**ADDENDUM NO. 1**  
**QUESTIONS AND ANSWERS**

**September 4 , 2020**

**Montgomery County Shared Services Facility**

A-103

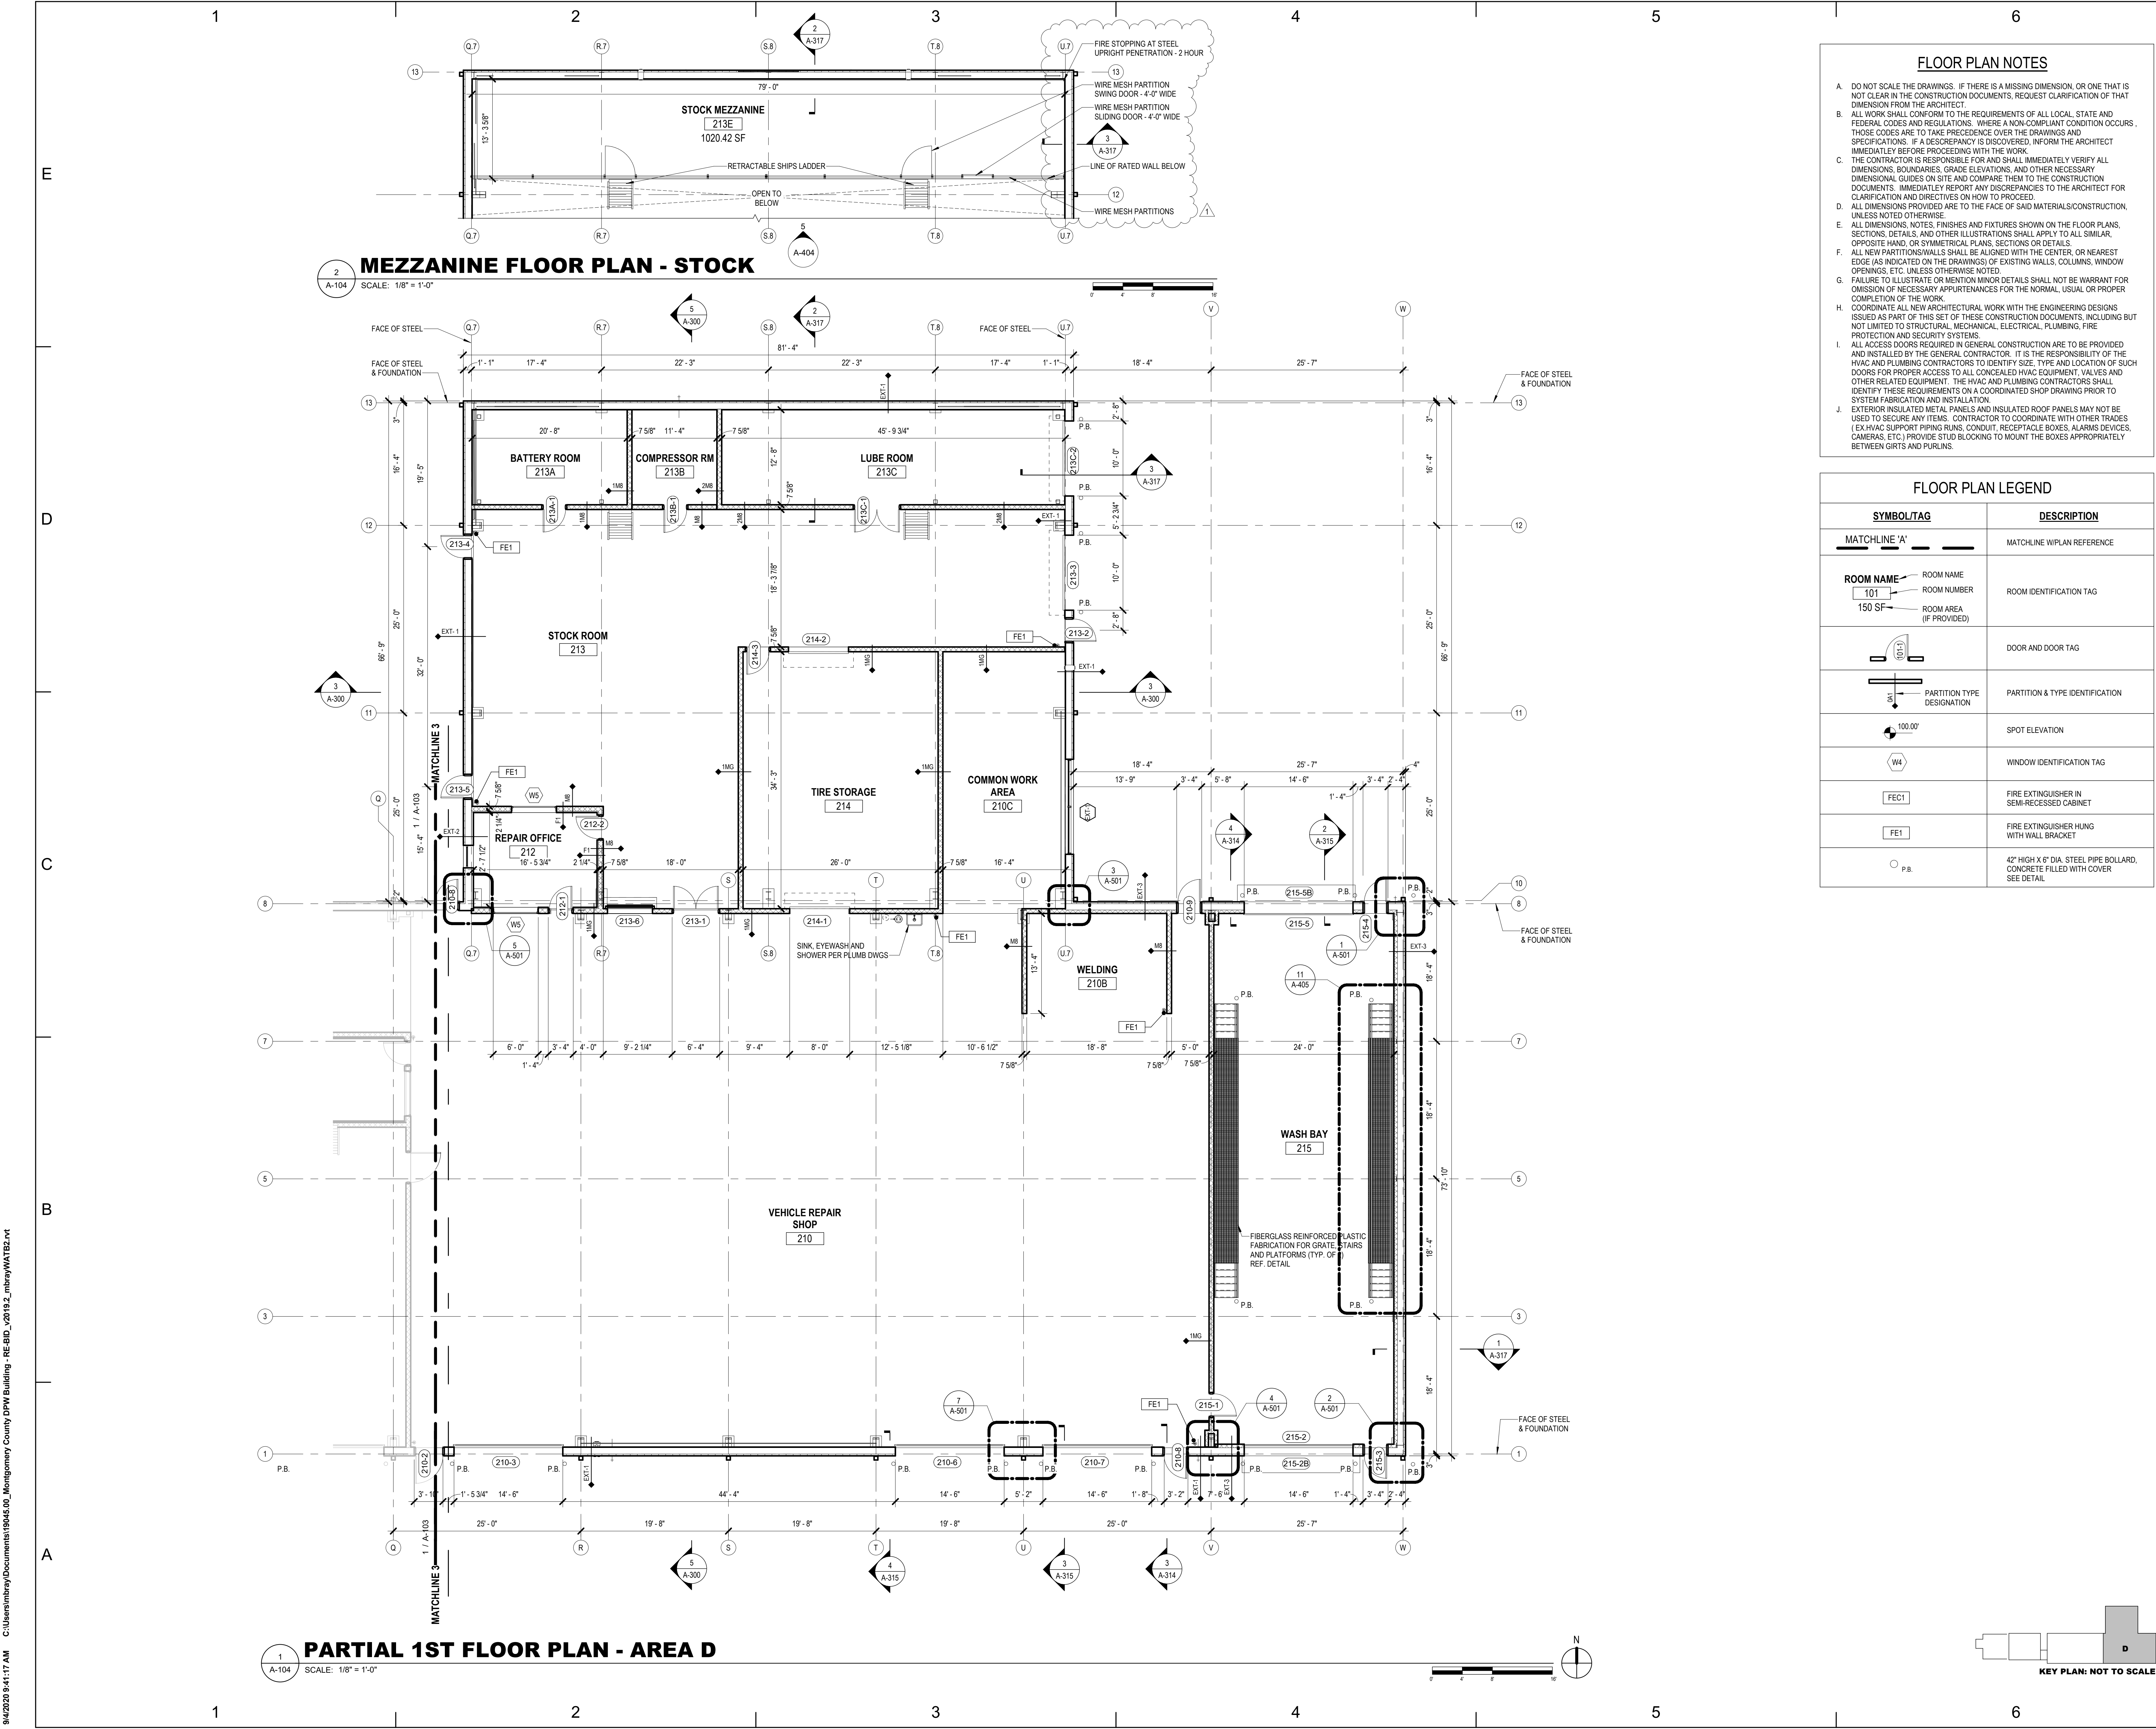
Please provide dimensional information on the wire mesh partitions, none is provided.

The wire mesh partitions are approximately 8’-3” high, some manufacturer’s standards may vary from that dimension but that is the design intent. Also, due to the shape of the space that the partition is being installed there will be the need to modify the top edge of some of the partition to follow the slope of the roof/ceiling above. This is evident in the current drawings on sheet A-404, detail 5. Some clarifications have been provided on sheets A-103 and A-104 to provide some additional dimensions.
